URD CONSTRUCTION SPECIFICATIONS

Primary Enclosure Grounds

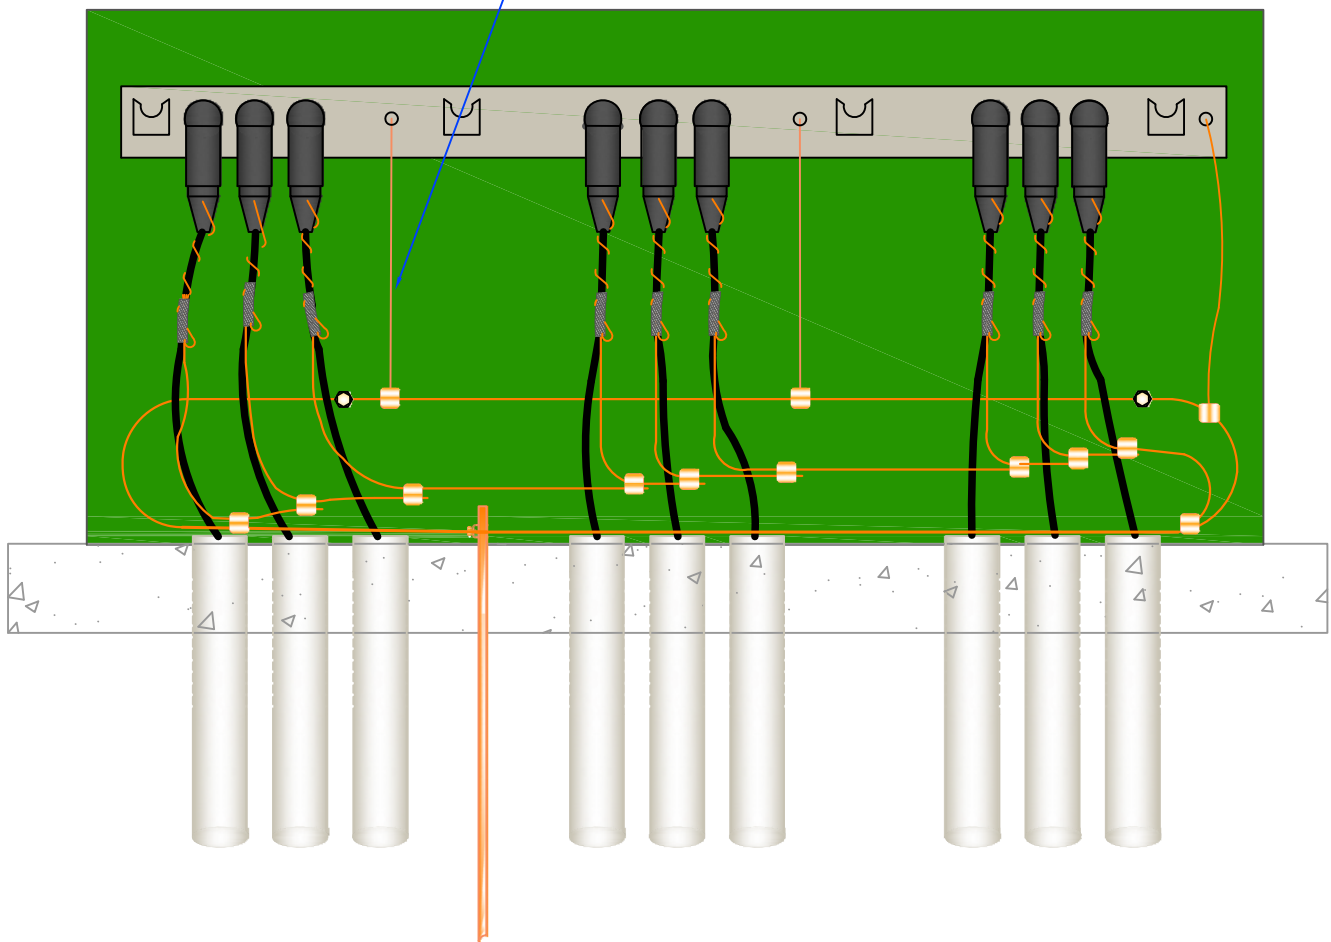
Tray ground should be independently connected to case ground, not the equipment lug.
